**SUBJECT:** NuScale Power, LLC Supplemental Response to NRC Request for Additional Information No. 134 (eRAI No. 8934) on the NuScale Design Certification Application

## Response to Request for Additional Information Docket No. 52-048

**NRC Question No.:** 03.07.02-15

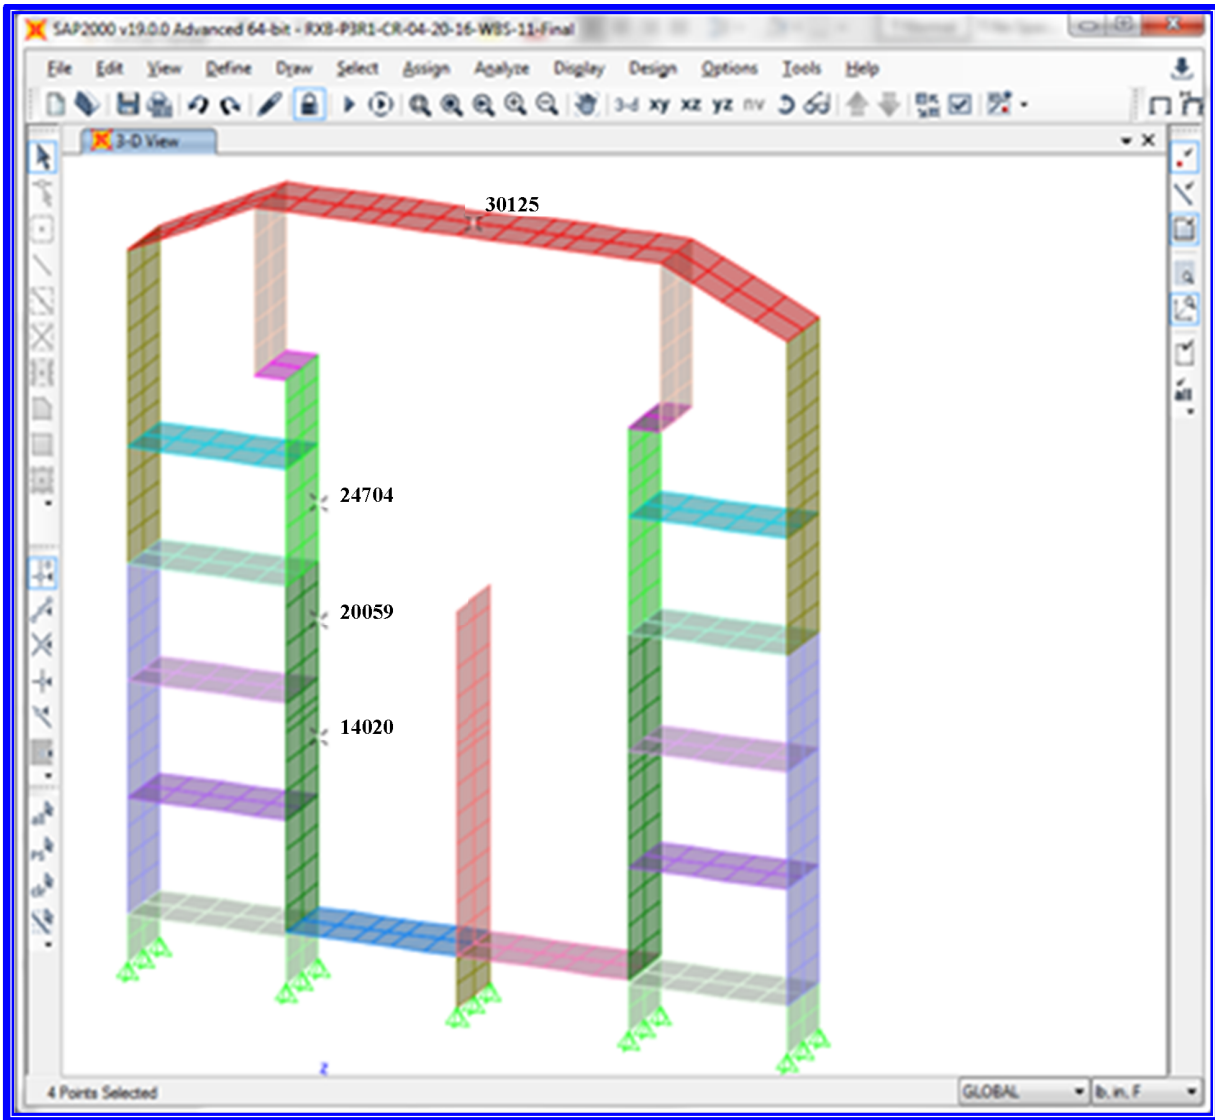
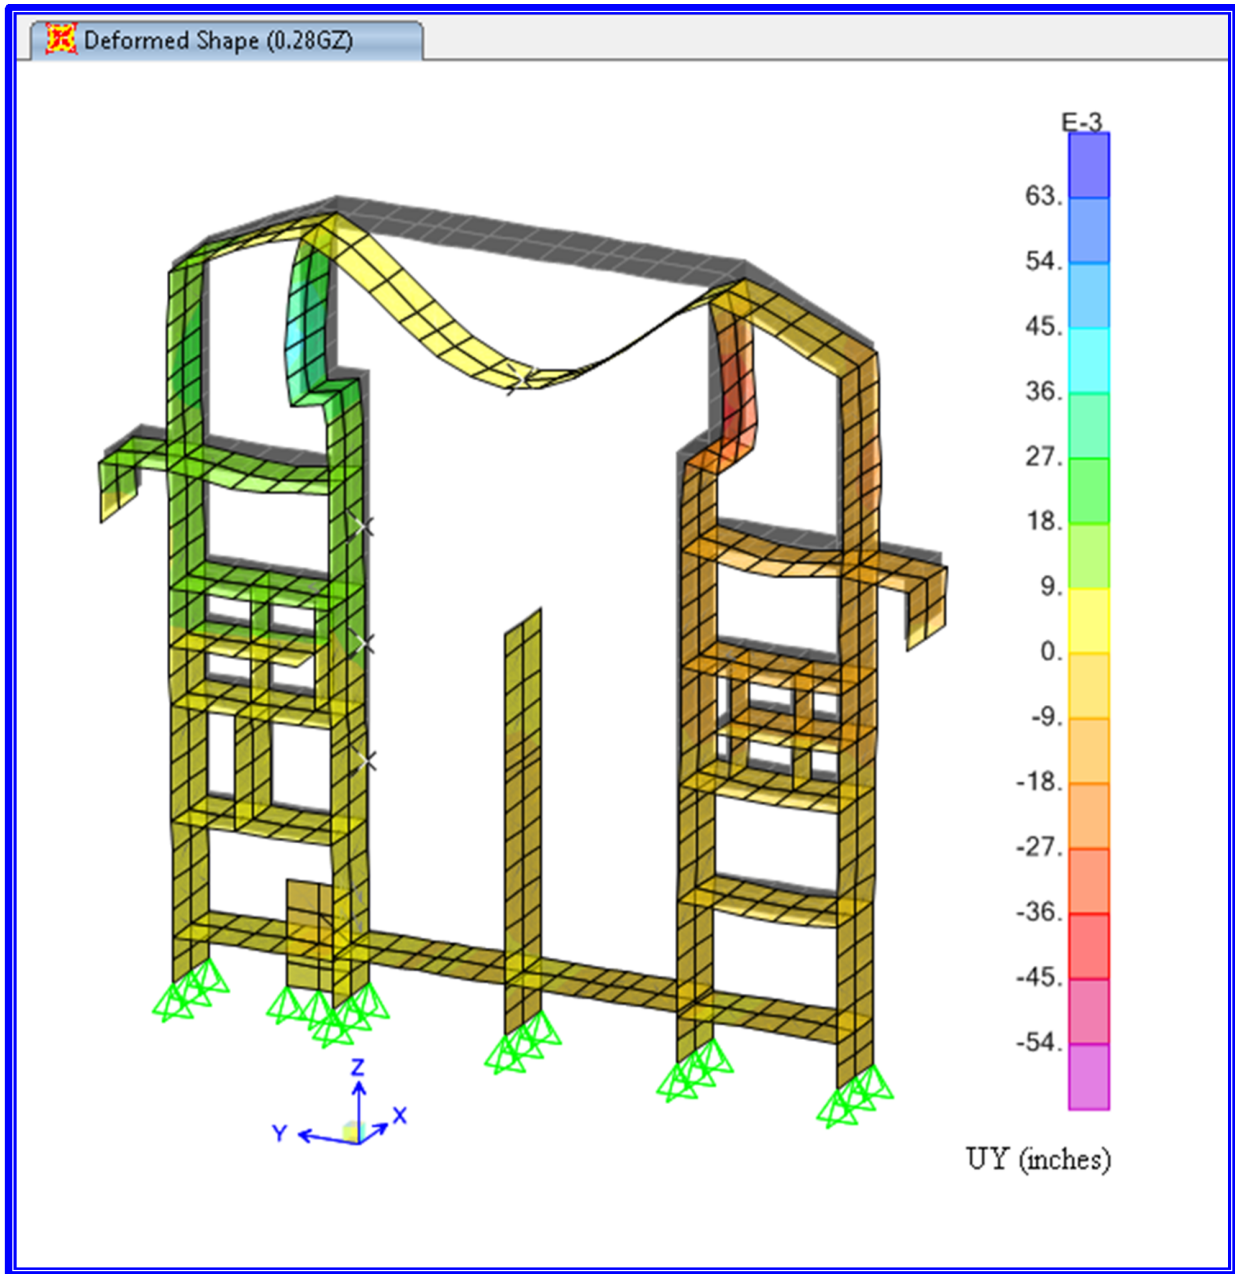
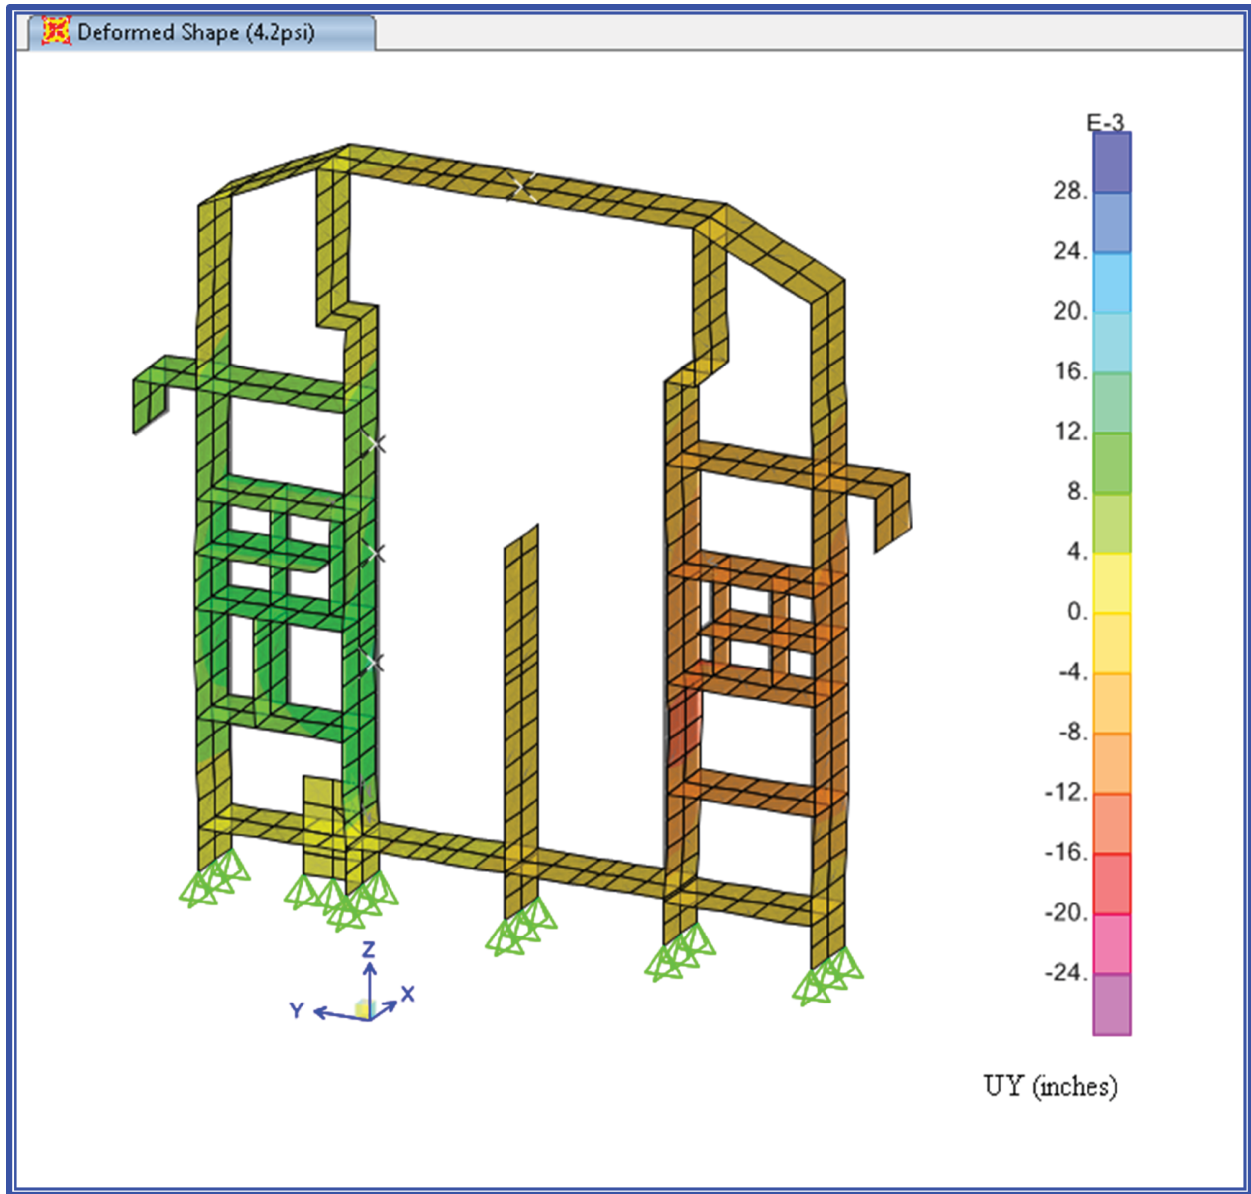
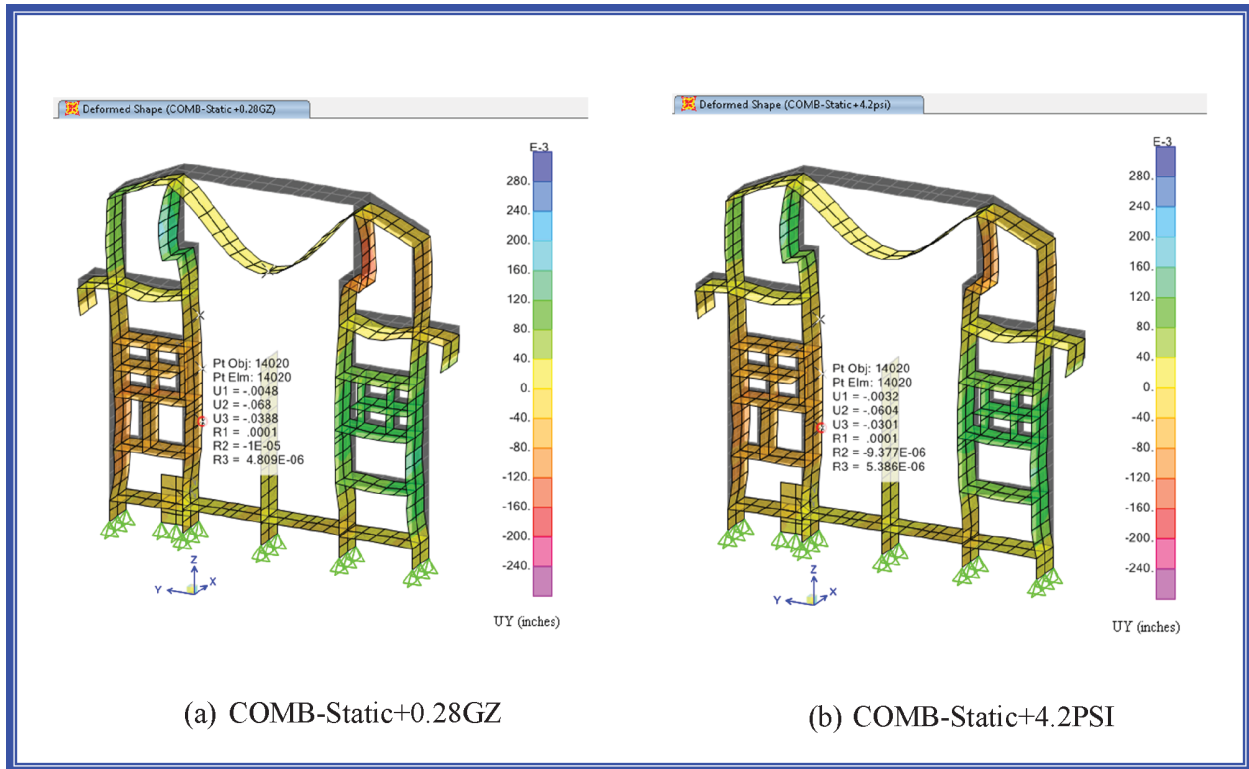
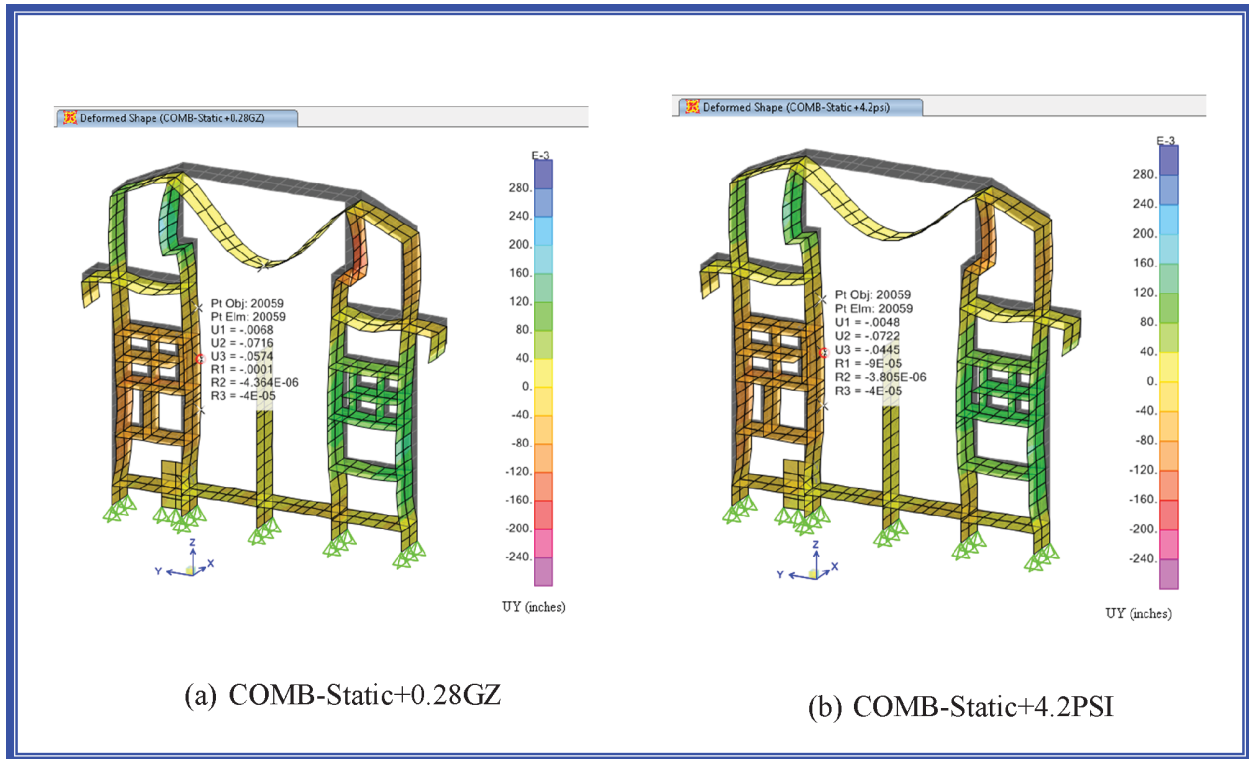
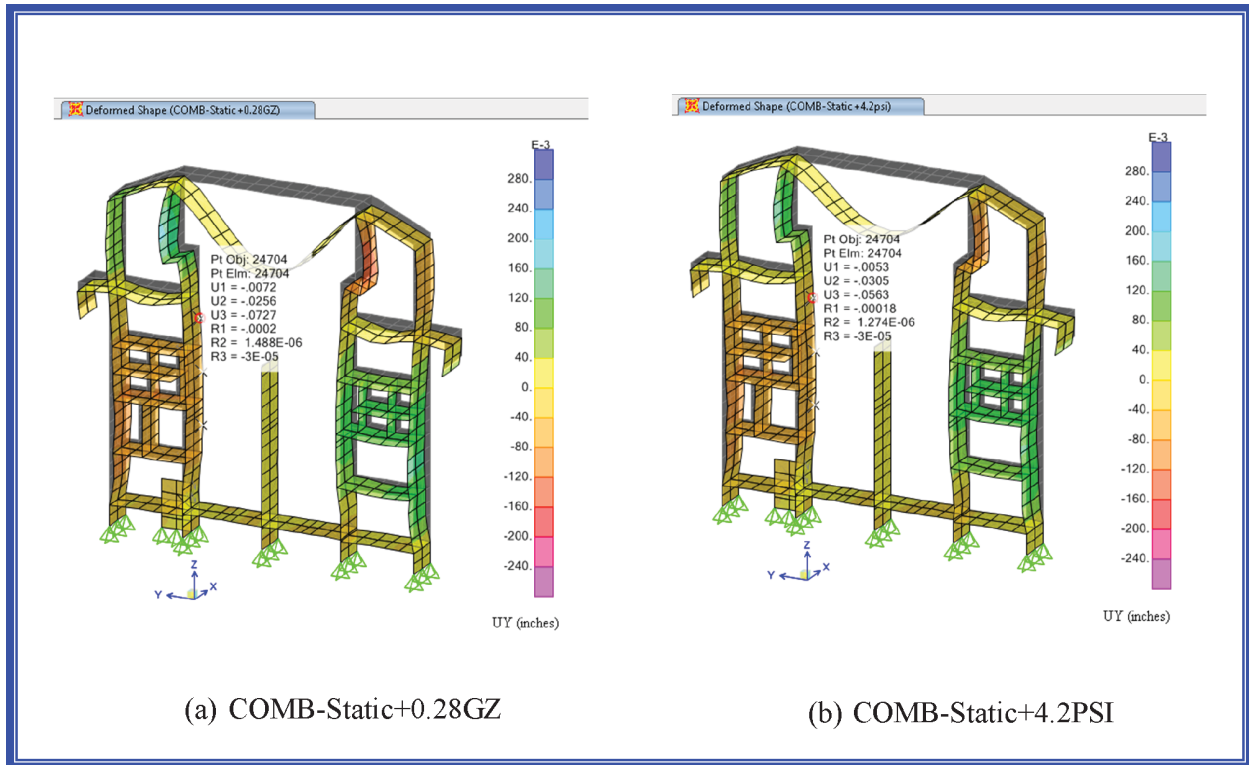
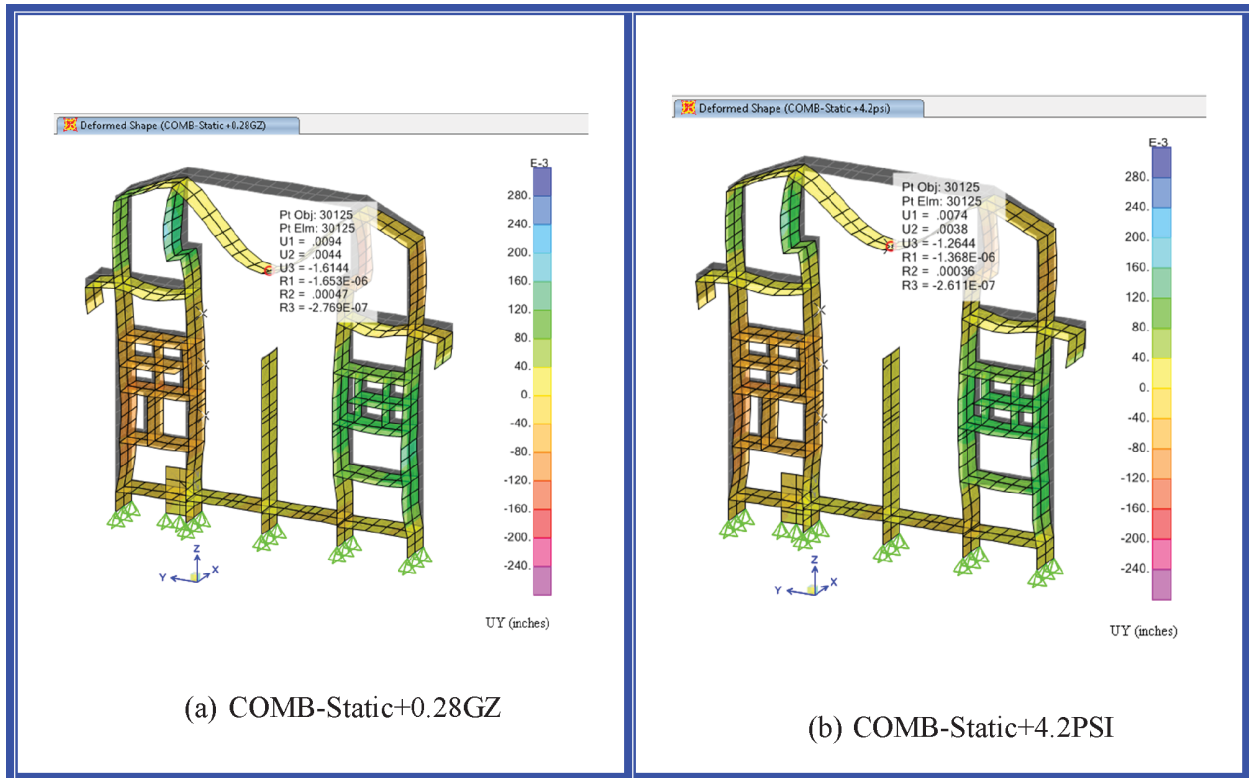
Therefore, the applicant is requested to provide figures or tables that compare pressure profiles on the pool walls and foundation obtained from the actual missing FSI pressure and from amplifying the gravity load by a factor of 1.28. If significant differences are identified in such comparison, the applicant should provide an evaluation demonstrating that the use of a gravity load factor of 1.28 results in an incremental design demand (forces, moments, deformations, etc.) that would have bound the increased demand should the applicant have used the actual pressure profile accounting for the missing FSI effect in SAP2000, for both the RXB pool walls and foundation.

Figure 2-1 shows the 3D view of the RXB slice section indicating the location of selected nodes for displacement comparison. The comparison of displacements values at the four selected nodes from the 0.28GZ and 4.2psi cases is listed in Table 2-1. The comparison of displacement values at the four selected nodes from the COMB-Static+0.28GZ and COMB-Static+4.2PSI cases is listed in Table 2-2. The corresponding lateral deformed shape plots of the RXB slice are plotted with identical contour zoom factors in Figure 2-4 through Figure 2-7. The RXB wall and roof displacements with 0.28GZ loading are generally higher than those with 4.2psi loading.
